82540EM Gigabit Ethernet Controller Specification Update

October 10, 2005

The 82540EM Gigabit Ethernet Controller may contain design defects or errors known as errata that may cause the product to deviate from published specifications. Current characterized errata are documented in this Specification Update.

11. 1.5V Regulator Control Circuit Start Up

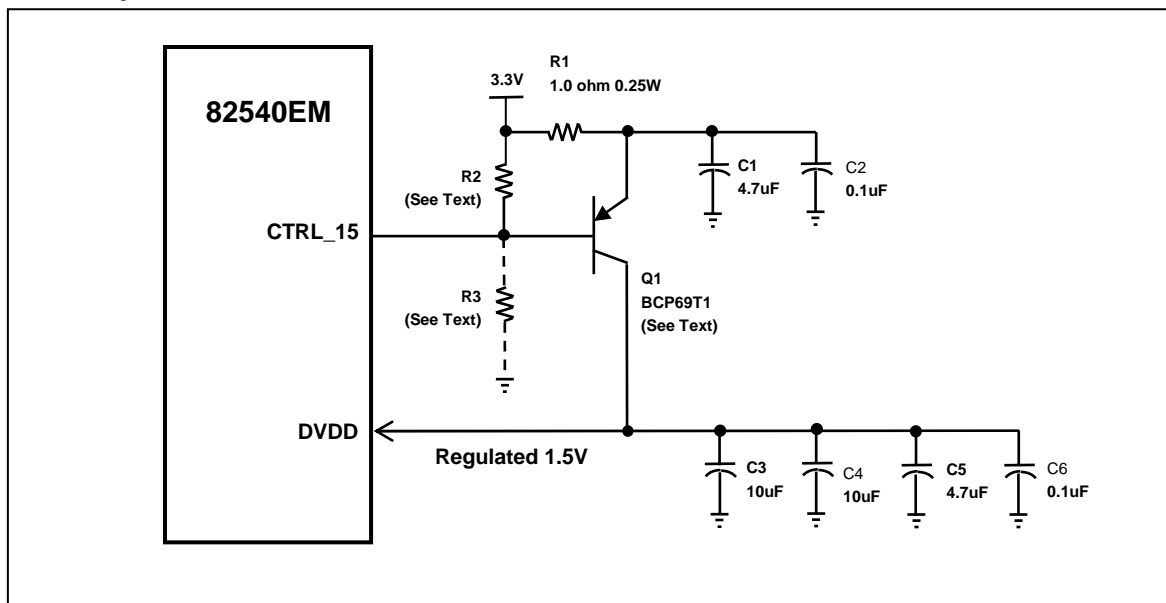
Problem: The 82540EM product contains on-chip LDO voltage regulation controllers for both 1.5V and 2.5V. The 1.5V regulator control output, CTRL_15, sometimes powers up in a high impedance state due to a digital portion of the feedback-control circuit which requires 1.5V to be present to operate correctly. The rate of occurrence of this problem may appear to vary from device to device or with different PNP transistors.

Implication: When drive is absent on the CTRL_15 output, only leakage current from the CTRL_15 output will be present. Depending on the amount of leakage current and the gain (Beta) of the external PNP transistor, there may be

insufficient collector current ($I_C = I_B * \text{Beta}$) to adequately supply the 1.5V rail, and the 1.5V regulator circuit may not turn on. The 1.5V rail requires a minimum collector current of 5 mA to be generated and a 1.5V rail voltage of at least 600 mV to ensure that the digital portion of the circuit turns on correctly.

When the 1.5V regulator control output fails, the 2.5V regulator control output(s) may also fail, driving the 2.5V supply toward either 0V or the 3.3V rail. The absence of one or both of the 1.5V and/or 2.5V supplies prevents the Ethernet controller from operating correctly.

Workaround: Refer to the figure below. The regulator control output is Ball P11 on the 82540EM controller. Intel's original reference designs showed two external resistors, R1 and R2, in this circuit. The workaround is to completely remove R2 (shown in reference schematics as 5.1K) and place another resistor, R3, to connect between the CTRL_15 output and ground, in order to create additional base current and ensure sufficient collector current is generated.

Due to variations in PNP minimum/maximum transistor gain, this circuit must adhere to specific requirements for the PNP transistor, R3 resistor value, and configuration of the 82540EM controller. Follow **workaround instructions** in Technical Advisory TA-147, "Possibility of 1.5 Voltage Regulator Failures on 82540EM LOM Designs." **Special Note:** Workarounds differ among the 82540EM, 82545EM and 82546EB controllers and each controller has a separate technical advisory.
